Preliminary Development Review Report

Tracking Number:	PDR 1001468
Applicant:	ALATUS LLC 800 NICOLLET MALL #2850 MPLS, MN 55402
Site Address:	200 CENTRAL AVE SE 113 2ND ST SE
Date Submitted:	12-JUL-2016
Date Reviewed:	20-JUL-2016

Construction of a new 40-story, 214 unit luxury residential tower with approximately 6,700 square feet of retail on the ground floor, three levels of underground and three levels of above ground parking (of which 69 would be tandem). The existing building on site, the Washburn McReavy Funeral Chapel building at 200 Central Ave SE, formerly known as the St. Anthony Commercaill Club, and an addition known as the St. Anthony Athletic Club building at 113 2nd Street SE, will be demolished.

200 CENTRAL AVE
GARBAGE TRUCK TURN SM
EX-1

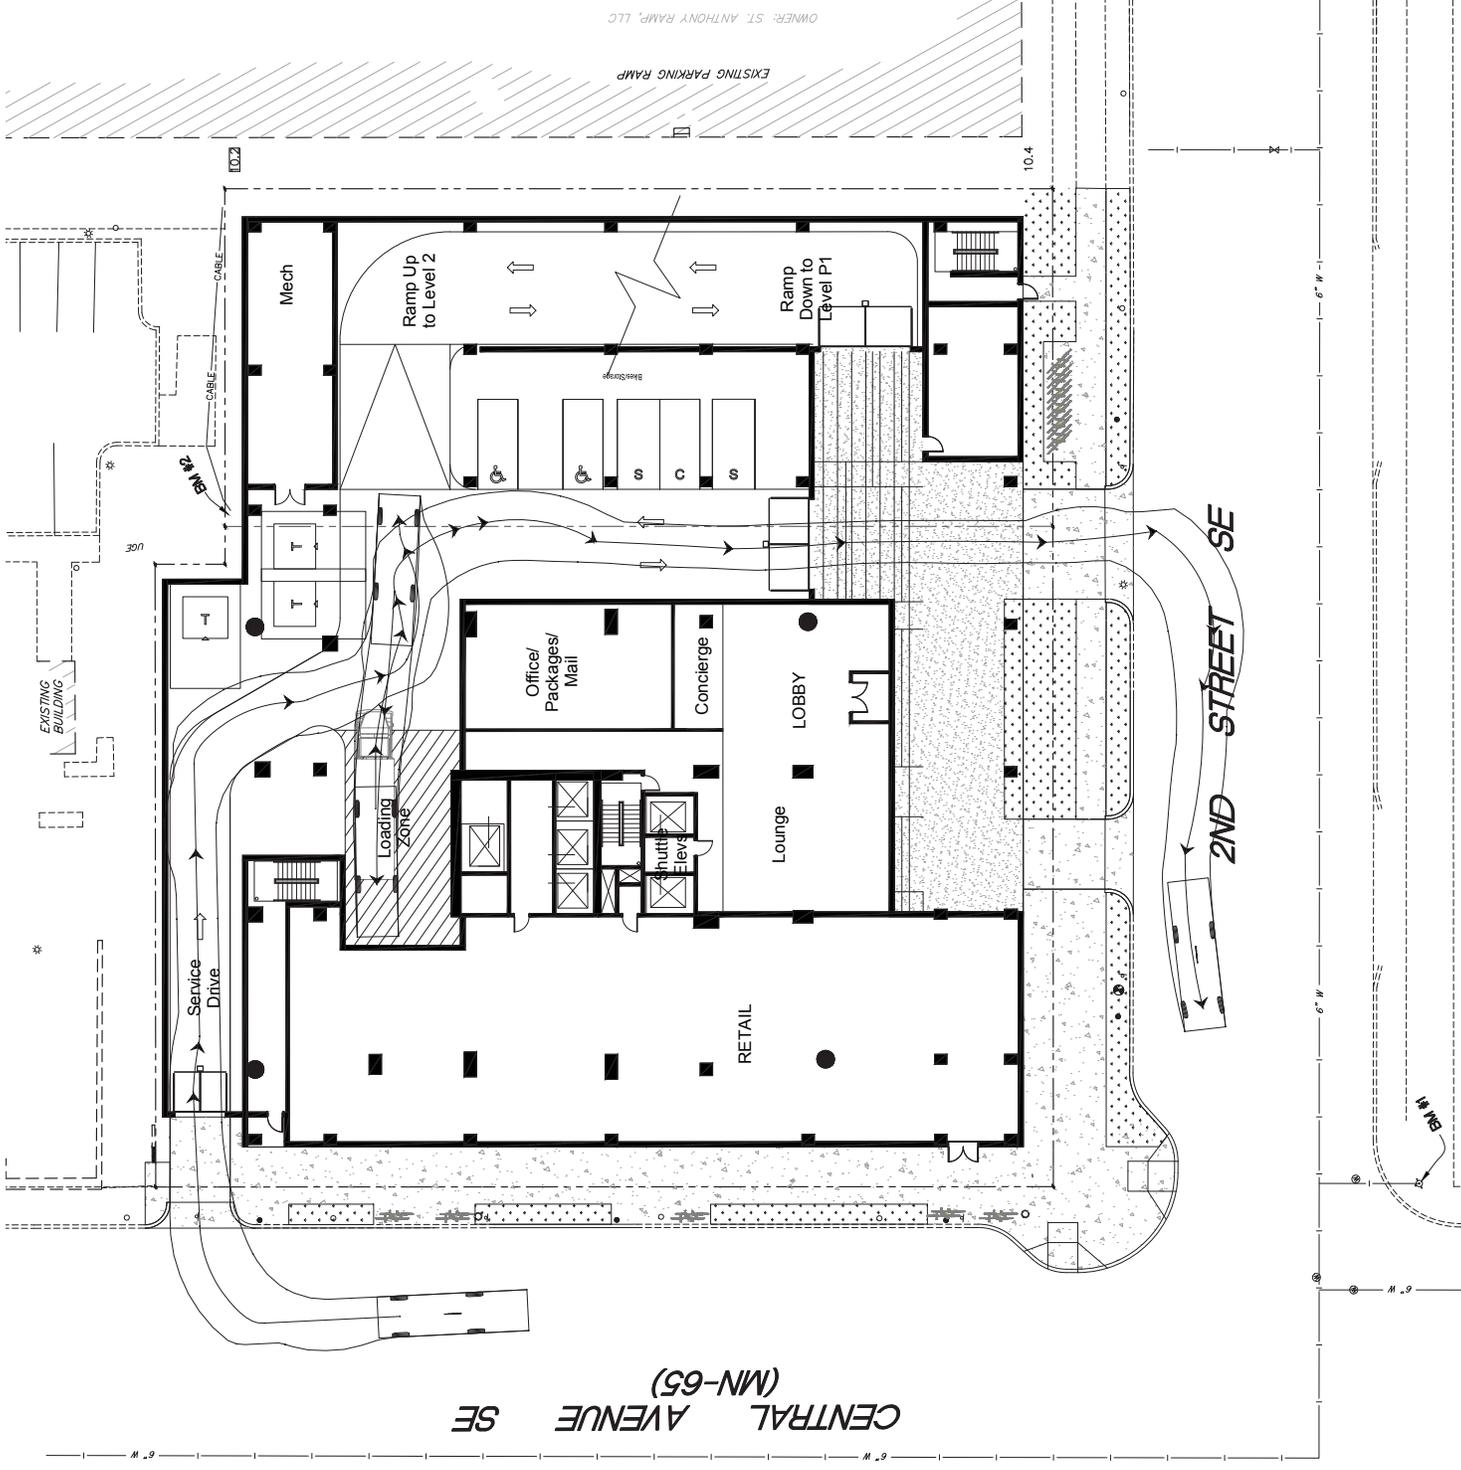
- The Applicant shall note the location of any existing Metro Transit "bus stops" on the site plan.
- Current ordinance states that all maneuvers associated with loading, parking or sanitation pick up for a private development shall occur on private property. Please provide a narrative explaining the trash removal operations on sheet EX-1.
